The potential application of the TfL Direct Vision Standard in UNECE regulation – **Response to ACEA limit values**

Loughborough University Design School (LDS): Design Ergonomics Research Group
Research Sponsored by Transport for London and the UK Department for Transport

Analysis of Cat A – ACEA proposal (8.50m³) SCANIA new cab design

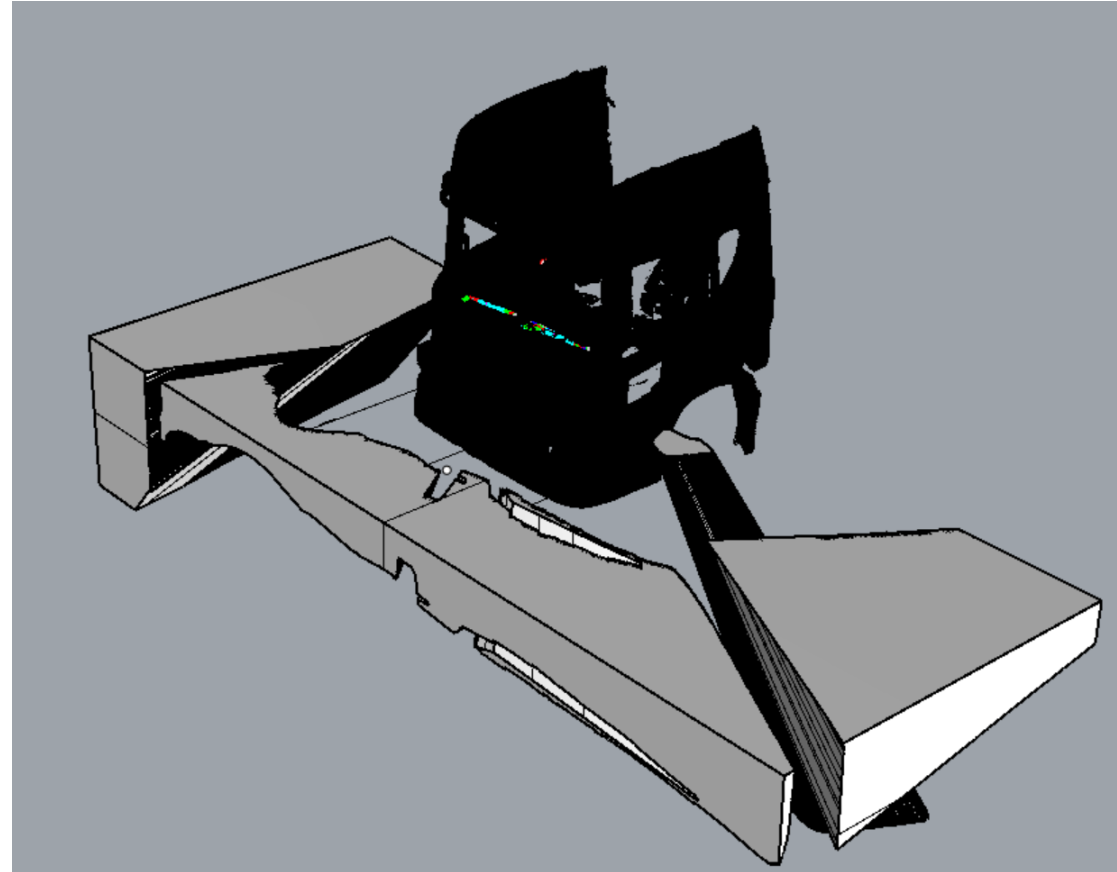
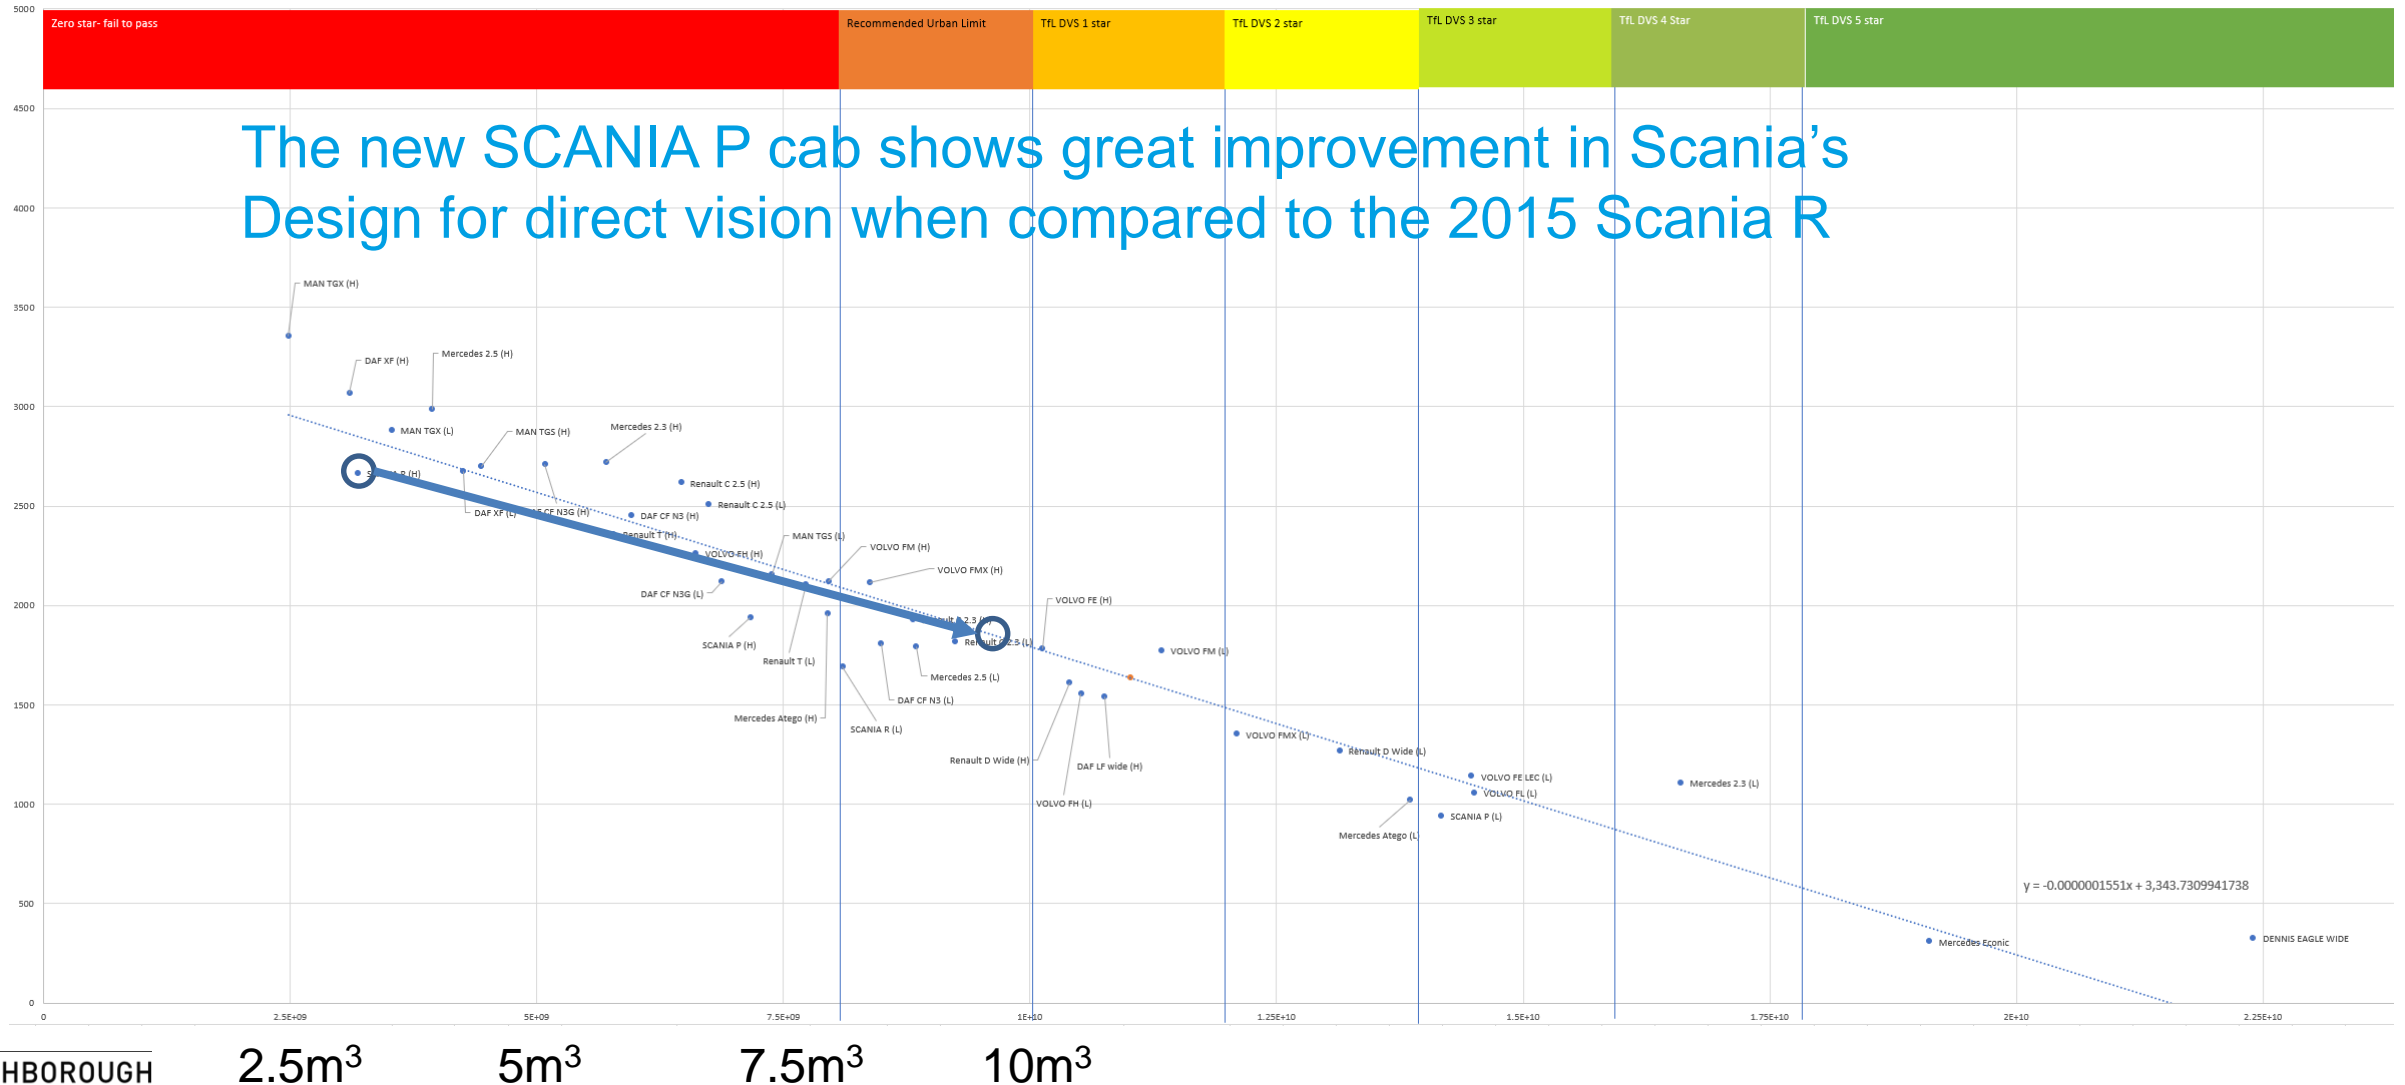
- New SCANIA P cab mounted at SCANIA R highest possible cab height (**LONG HAUL**)
- The AHP height is **1770mm**
- Removed mirrors
- Used 250mm aero to the front
- Total Volume **9.54m³**
- Average VRU distance to the front = **2.025m**
- NOTE: Scania R high average VRU distance = 2.6m
- Therefore a 2019 SCANIA P cab can be mounted at the maximum cab height of the 2015 SCANIA R, and surpass the ACEA CAT A limit, with a **very small VRU** blind spot to the front of the vehicle

- New SCANIA P cab mounted at SCANIA R highest possible cab height (**LONG HAUL**)
 - Removed mirrors
 - Used 250mm aero to the front
 - Total Volume 9.54m³
 - Average VRU distance to the front = 2.025m
-
- Volume to the front = 1.73m³
 - Volume to the passenger side = 2.54m³
 - Volume to the driver's side = 5.27m³
-
- Cat A 11m³ LDS = Fail
 - Cat A 8.5m³ ACEA = Pass
 - Cat B 8m³ LDS = Pass
 - Cat B 6m³ ACEA = Pass
 - It is acknowledged that these volumetric scores do not meet the minimum requirements suggested by the LDS in the 15th meeting for a separated approach for level A. The majority of the volume is seen to the driver's side

Analysis of Cat B – ACEA proposal (6m³) MAN TGX

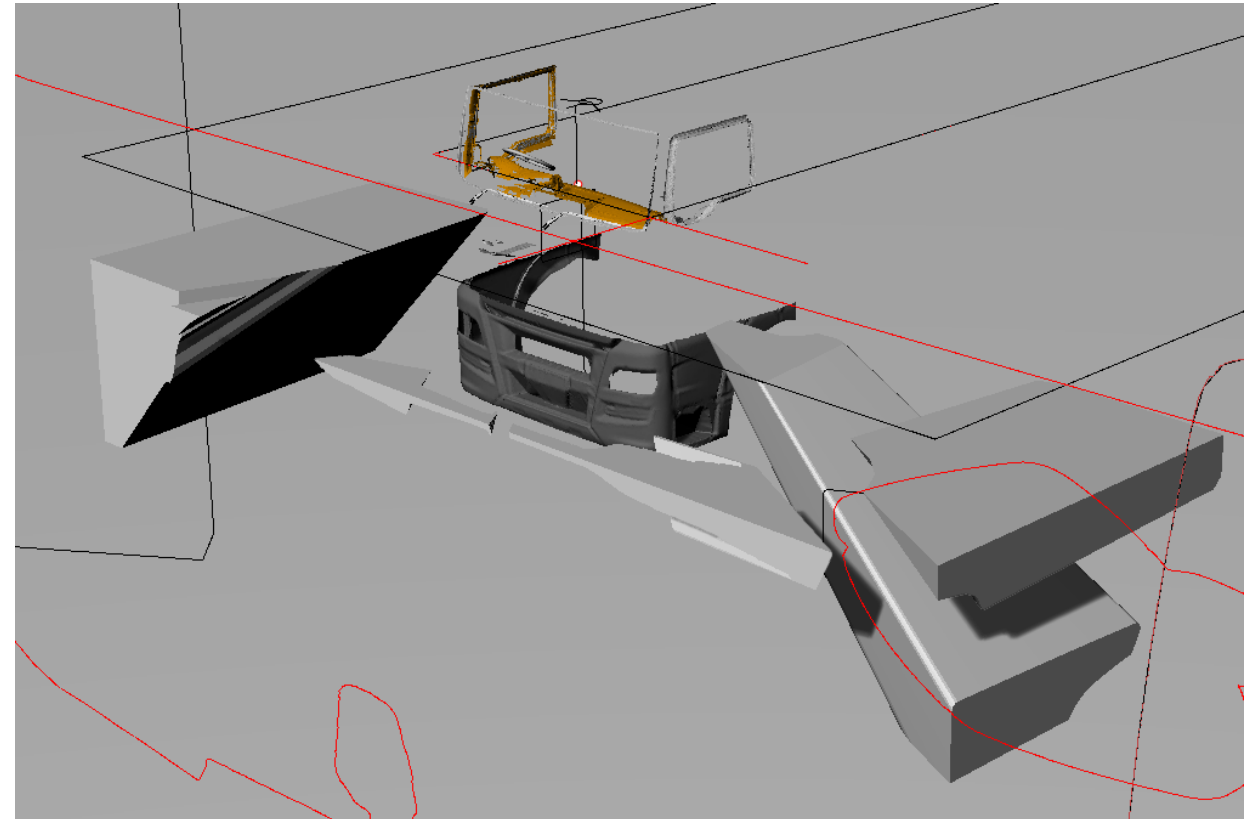
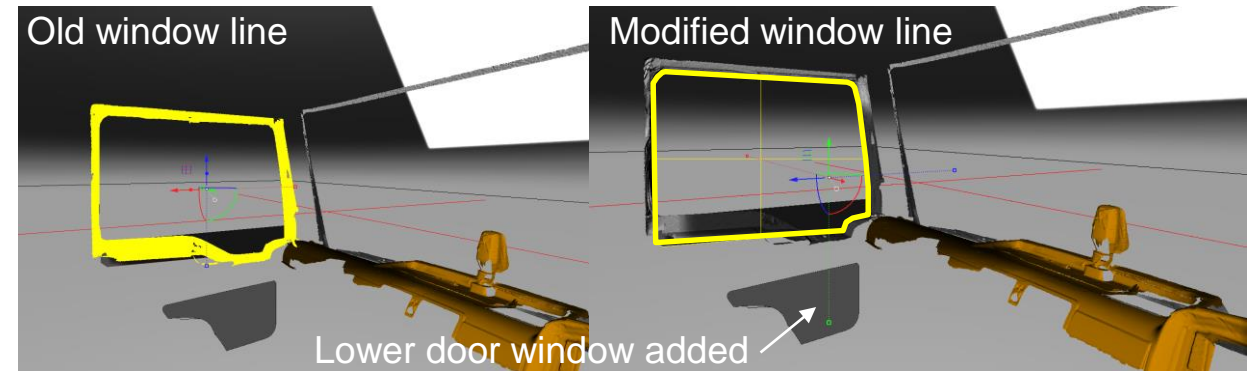
- Worst performing vehicle in the TfL analysis
 - **Removed mirrors**
 - **Used 250mm aero feature to the front**
 - **Adjusted window line to remove the 'hump'**
 - **Added lower door window**
 - **Total Volume 8.04m³**
 - Average VRU distance to the front = **3.189m**
-
- Volume to the front = 0.14m³
 - Volume to the passenger side = 3.57m³
 - Volume to the driver's side = 4.33m³
-
- Cat A 11m³ LDS = **Fail**
 - Cat A 8.5m³ ACEA = **Fail**
 - Cat B 8m³ LDS = **Pass**
 - Cat B 6m³ ACEA = **Pass**
-
- Large blind spot exists to the front of the vehicle between what can be seen through indirect vision and direct vision

Analysis of Cat B – ACEA proposal (6m³) MAN TGX

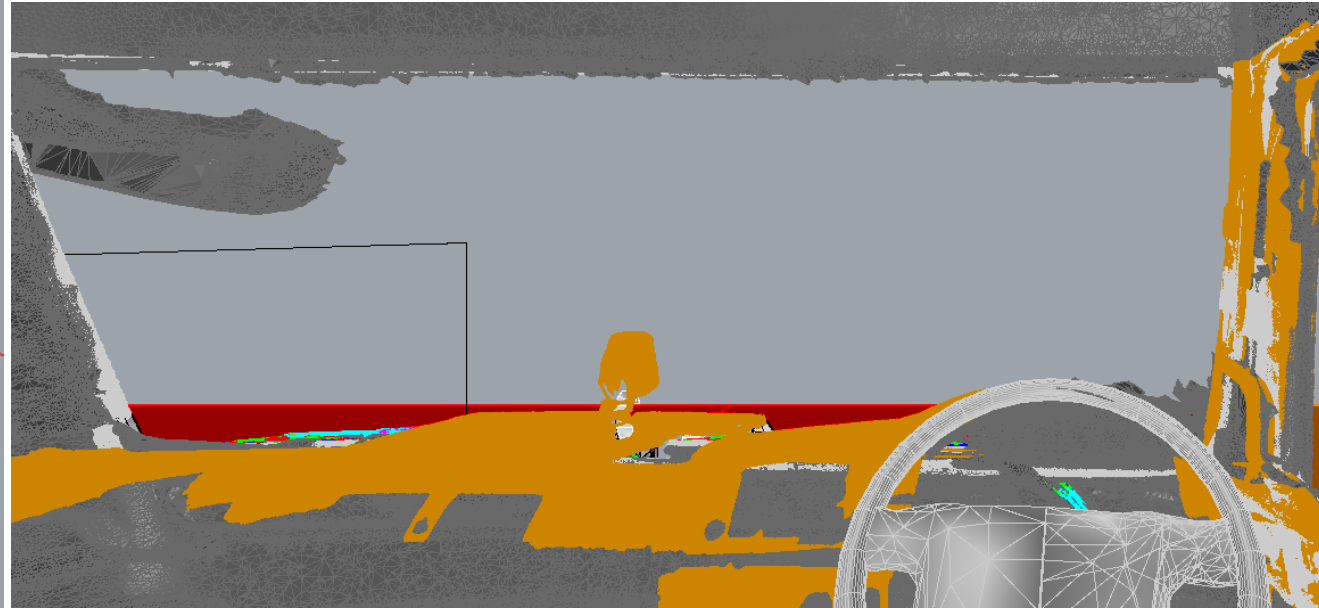
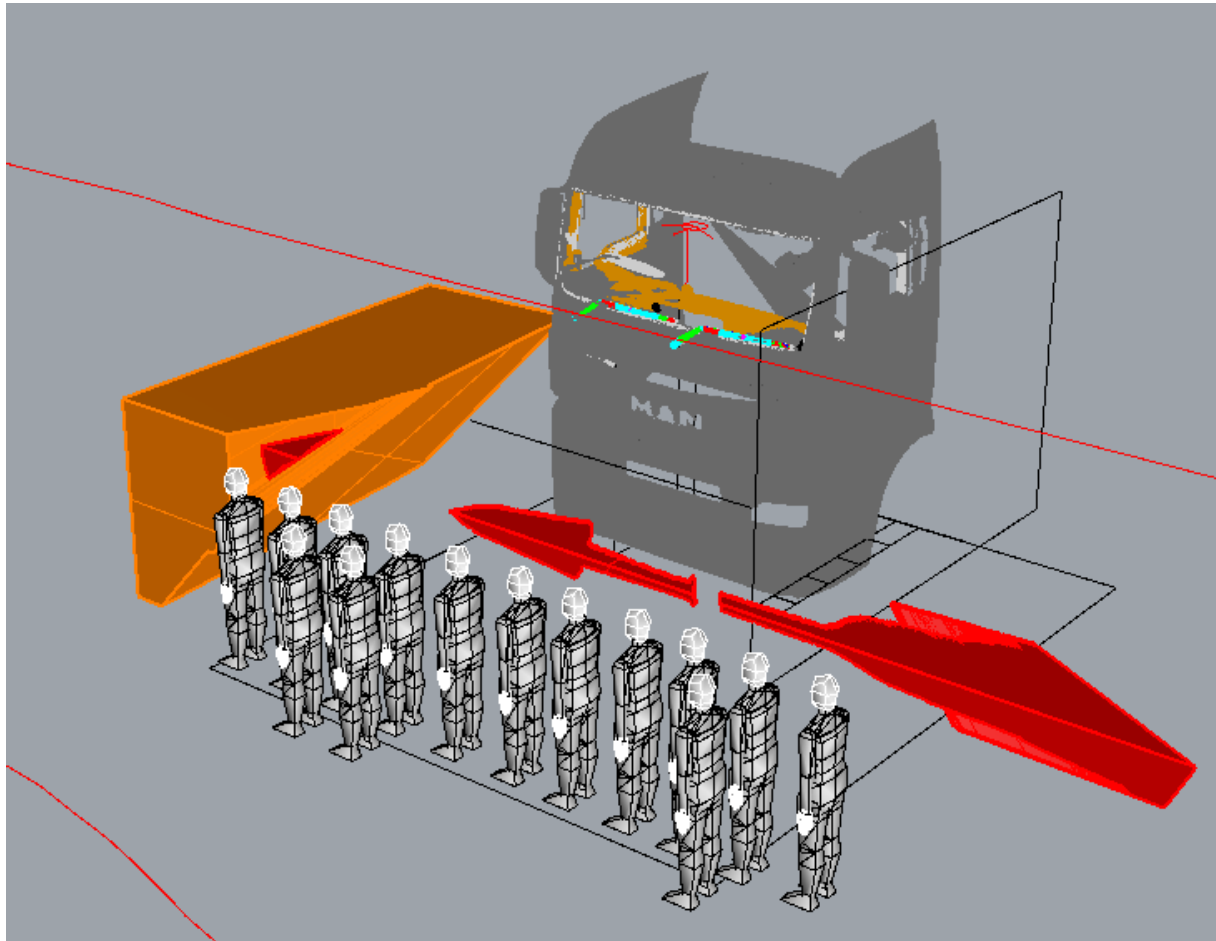
- All of these VRUS are not visible to the driver of this vehicle at the edge of the Class VI mirror zone. **They are in a blind spot**

Analysis of Cat B – ACEA proposal (6m³) MAN TGX

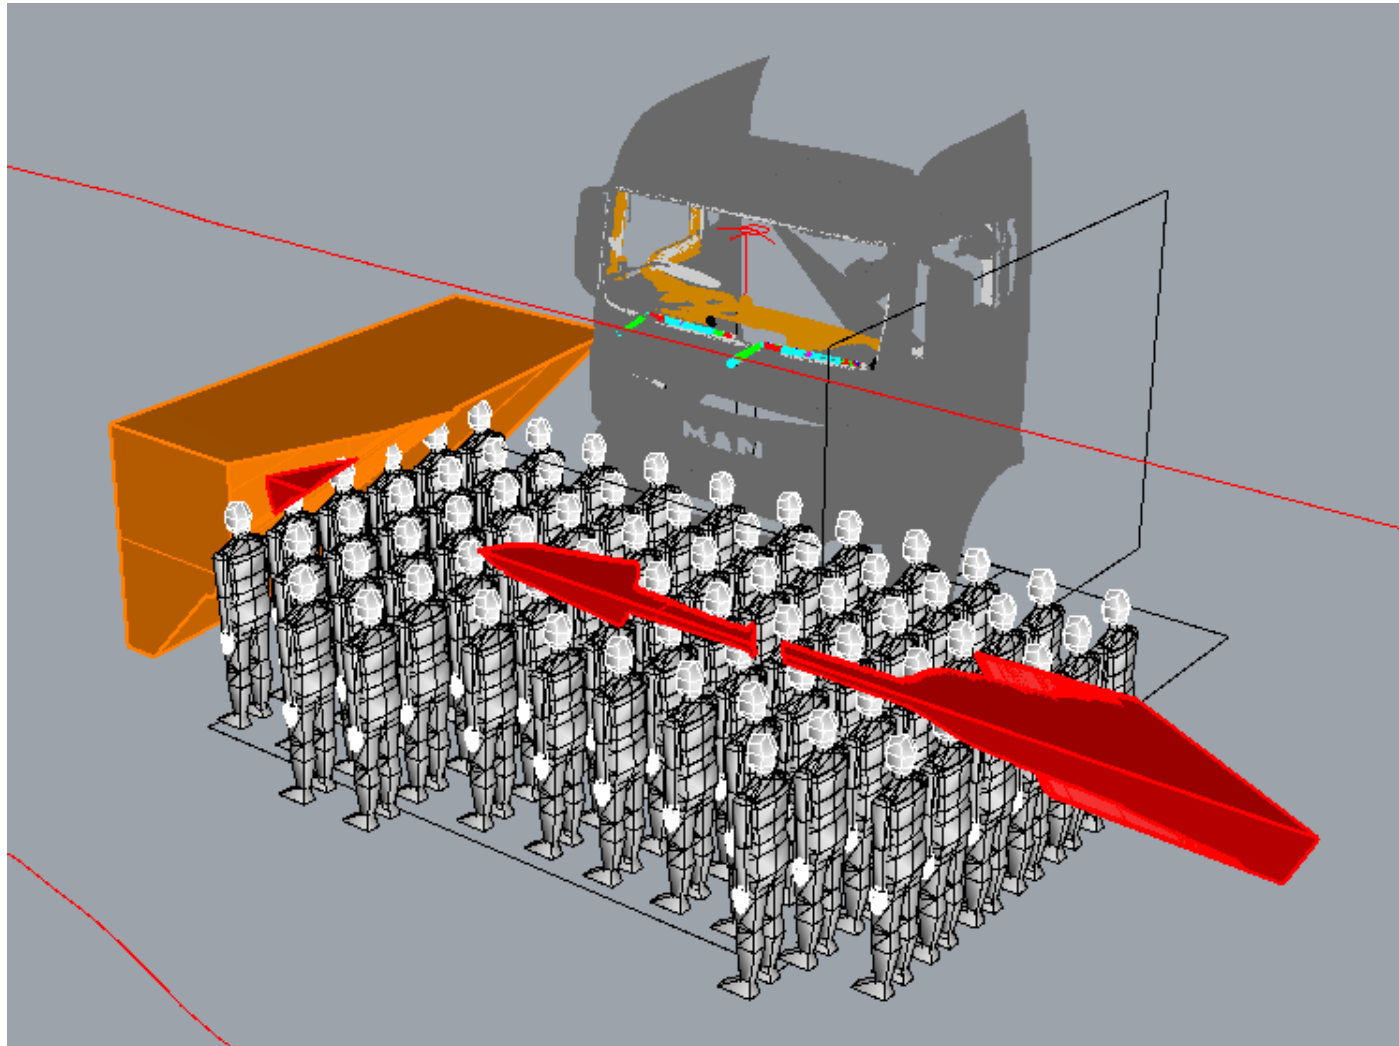
- If the driver does not use the Class VI mirror all of these VRUs are not visible using forward vision to the driver of this vehicle

Analysis of Cat B – ACEA proposal (6.0m³) DAF XF

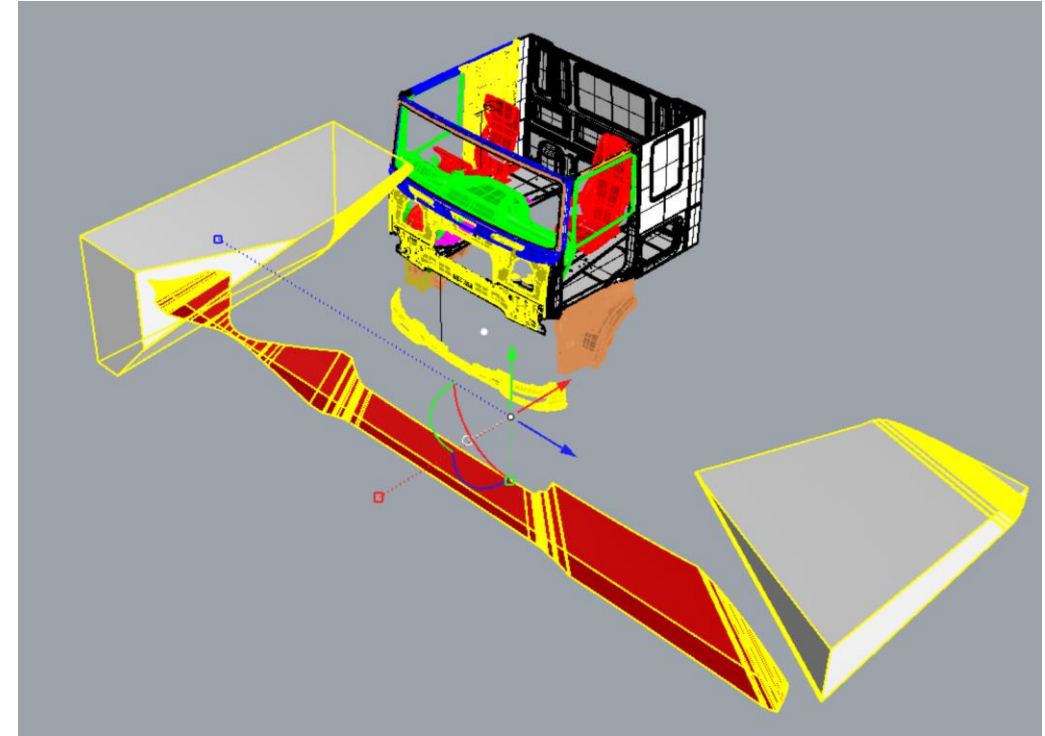
- 2nd worst performing vehicle in the TfL analysis
 - **Removed mirrors**
 - **Used 250mm aerodynamic feature to the front**
 - **Adjusted window line down by 50mm**
 - Alternatively we could add a lower door window
 - Total Volume **6.1m³**
 - Average VRU distance to the front = **3.275m**
-
- Volume to the front = 0.31m³
 - Volume to the passenger side = 1.03m³
 - Volume to the driver's side = 4.72m³
-
- Cat A 11m³ LDS = **Fail**
 - Cat A 8.5m³ ACEA = **Fail**
 - Cat B 8m³ LDS = **Fail**
 - Cat B 6m³ ACEA = **Pass**
-
- And leaves a large blind spot to the front of the vehicle **with a similar VRU obscuration issue to the MAN TGX**

Analysis of Cat A – ACEA proposal (8.5m³) DAF CF (highest)

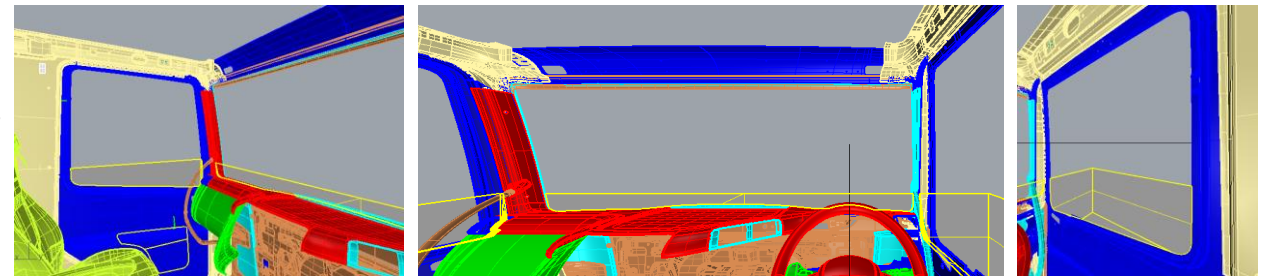
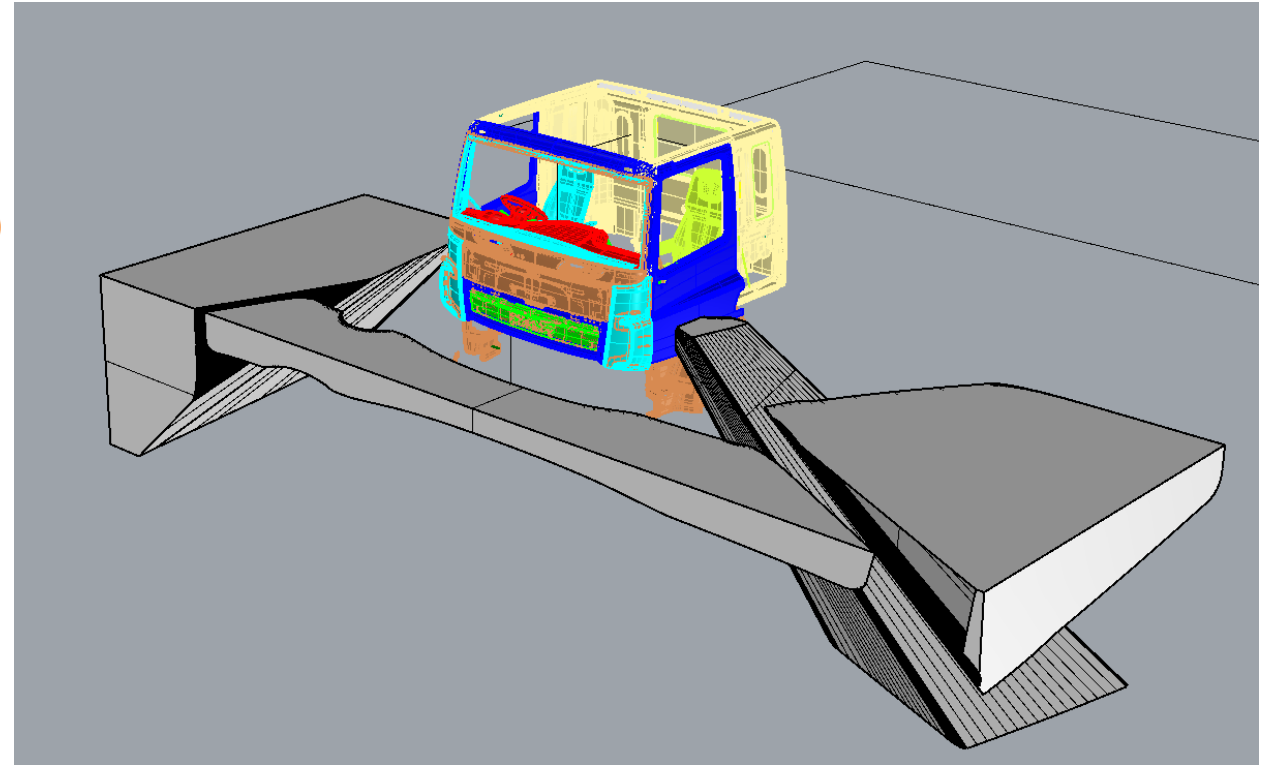
- 2nd worst performing vehicle in the TfL analysis
- **Removed mirrors**
- **Added lower door window**
- **Removed wipers (e.g. lowered below windscreen line)**
- **Total Volume 9.02m³**
- Average VRU distance to the front = **2.641m**
- Volume to the front = 0.57m³
- Volume to the passenger side = 3.56m³
- Volume to the driver's side = 4.89m³
- Cat A 11m³ LDS = Fail
- Cat A 8.5m³ ACEA = Pass
- Cat B 8m³ LDS = Pass
- Cat B 6m³ ACEA = Pass
- And leaves a large blind spot to the front of the vehicle for a vehicle that would operate in an Urban Environment
